Certificate of Appropriateness Application and Preliminary Review
BAR 08-03-05
608 Preston Avenue
TM 32 P 14
Bushman Dreyfus Architects / Andy McGinty
Final Submission of proposed rehabilitation including partial demolitions, and Preliminary Site
Plan

## CITY OF CHARLOTTESVILLE BOARD OF ARCHITECTURAL REVIEW STAFF REPORT April 15, 2008

Re.: King Lumber Building Site Plan Revisions

# KING LUMBER BUILDING RENOVATION 608 PRESTON AVENUE

Proposed Site Plan King Lumber Building, 608 Preston Avenue

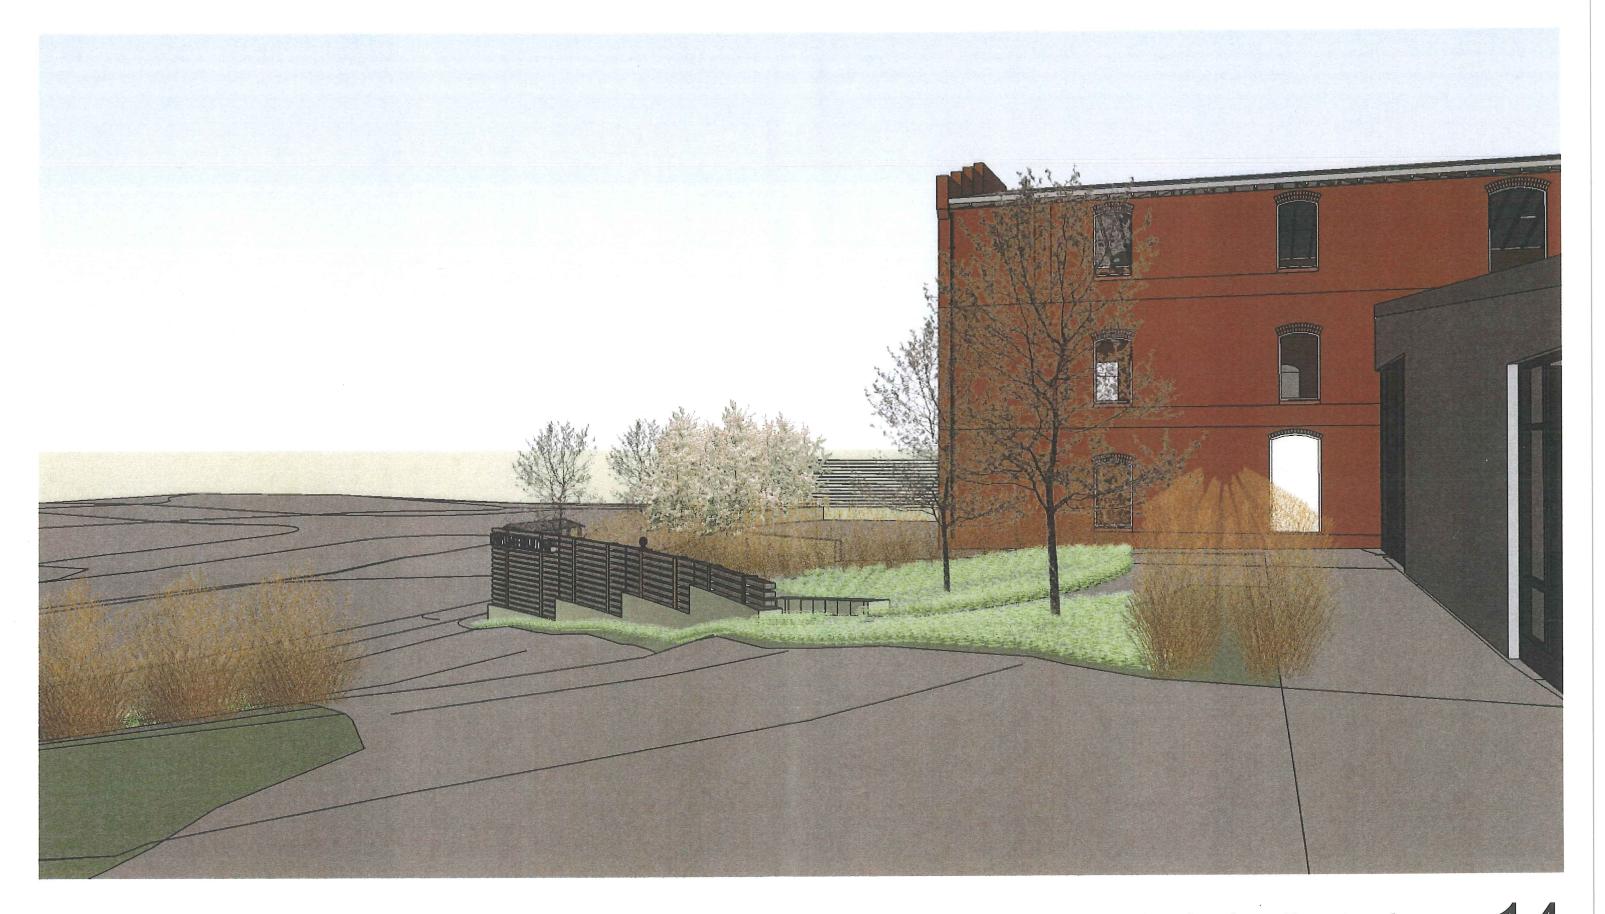
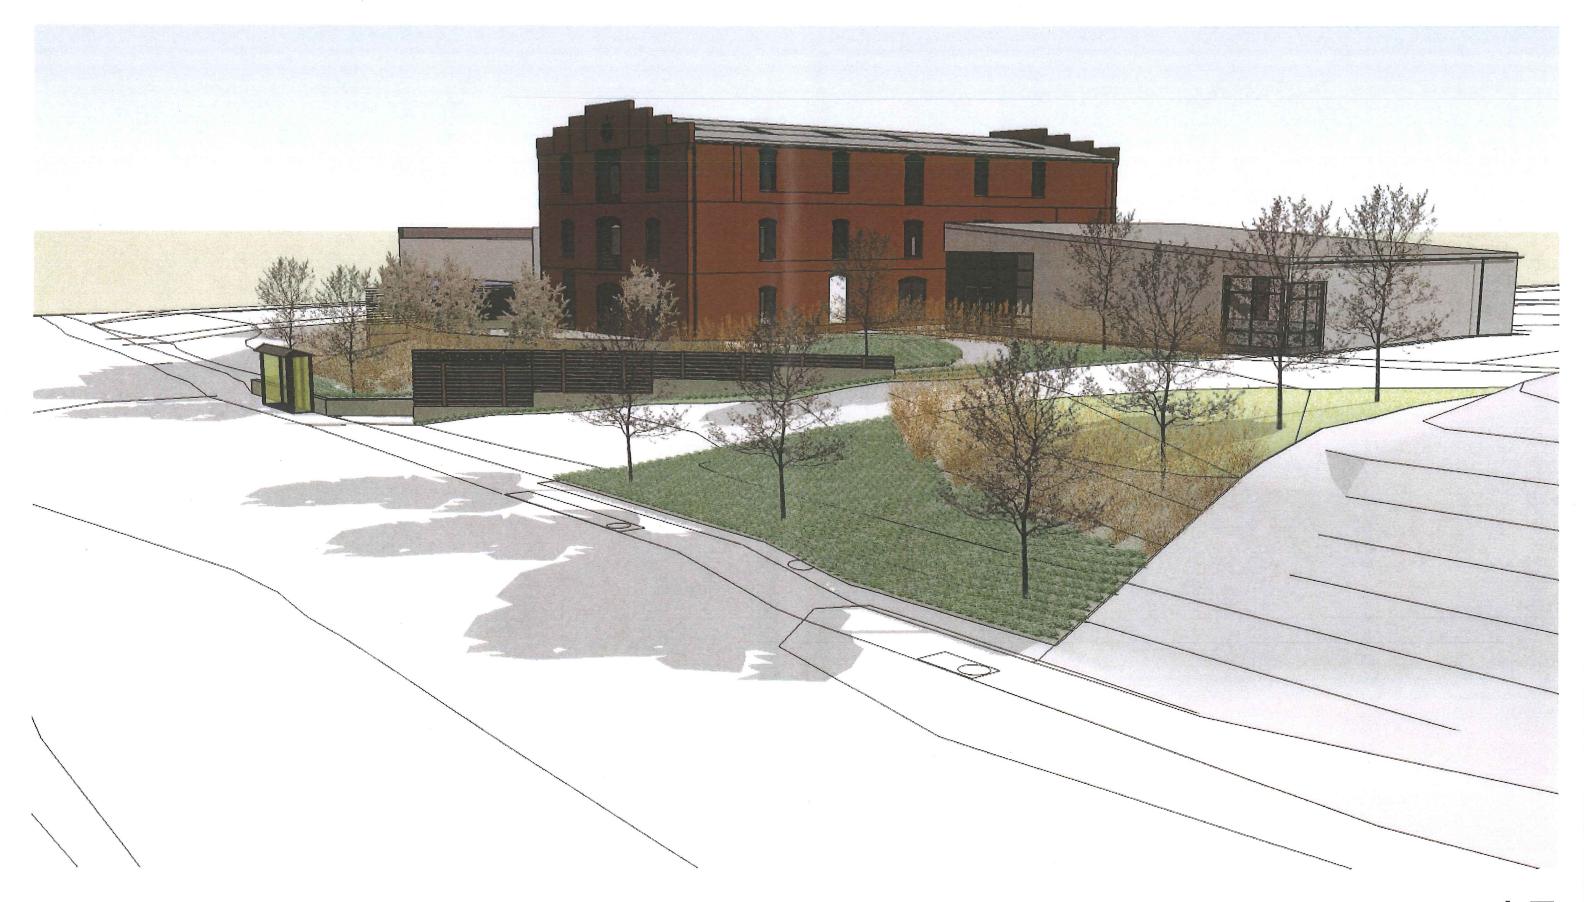
The site plan was discussed by the BAR on April 15, 2008. The applicant requested deferral. The BAR requested a section and pavement/plaza materials and patterns; they asked that you not obscure the base or left side of façade with landscaping; they questioned the honey locust species; they said the new design (axial relationship) is good. The BAR does not care to review the rear parking lot site plan.

The walls at Preston Avenue and adjacent Reid's include a fence on top constructed of rough cedar and 1" x 6" weathered steel straps. This construction is unusual but in this case may evoke railroad ties or a lumber yard. The heights of both wall/fences are excessive based on the guidelines. The lower concrete site walls are appropriate, as are the concrete/concrete pavers patio and sidewalk areas.

The rear parking lot landscaping must conform with the site plan requirements for interior parking lot landscaping, which includes medium shade trees. This will be confirmed during review of the site plan by the neighborhood planner.

The only other application that I would make comment on is the King Lumber project, specifically the site plan and proposed planting plan. I believe that the overall project has a great deal going for it and generally meets the guidelines, but I believe that the planting plan can still be improved. One of the central themes of the comments we made at the preliminary review was that the building's simplicity is its strength. It is a relatively prosaic structure; any improvements should respect its humble origins. I think that, by and large, the architects are respecting that comment with the buildings but they are losing sight of the same goal in the landscape. I find it fussy and over-designed. In most of the images submitted with the application, the building seems out of synch with its surroundings. It (the building) reminds me of the family dog who gets dressed up in lacy doll clothes and stuck in a baby carriage; more than anything, it just looks a little embarrassed. Specifically, I would ask if they could stick to shade trees, turf and fewer shrubs (both quantity and number of species). I don't think that the understory tres and the large masses of shrubs are compatible with the buildings.

The BAR does not usually approve a fence in the front that exceeds 4 feet. Please reconsider the fence adjacent Reid's.

Monument signs may not exceed 6 feet in height, or 24 sq ft in area. The wall/signage at the entrance does not meet our sign ordinance.

- 1) We reduced the height of the entrance wall by two and a half feet (2'-6") and removed signage from it all together.
- 2) We reduced the height of the screen wall between Reid's and the King Lumber terrace by two feet (2'-0") to a maximum height of five feet ten inches (5'-10").
- 3) We revised the landscape to be in character to the historic use of the property as a lumber yard. We removed the massive shrub plantings and have proposed native grasses that would occupy the hill along Preston Ave.

RESPONSE: is there something in the entry corridor regs that states 4' is the maximum height of a fence? I do not see anything about maximum fence height in the Entry Corridor regulations. Is it a limitation noted in the zoning ordinance?

RESPONSE: We didn't realize the screen wall would be considered a part of a monument sign. We will explore options such are removing the sign from that wall and other alternatives. Thanks for bringing this to our attention.
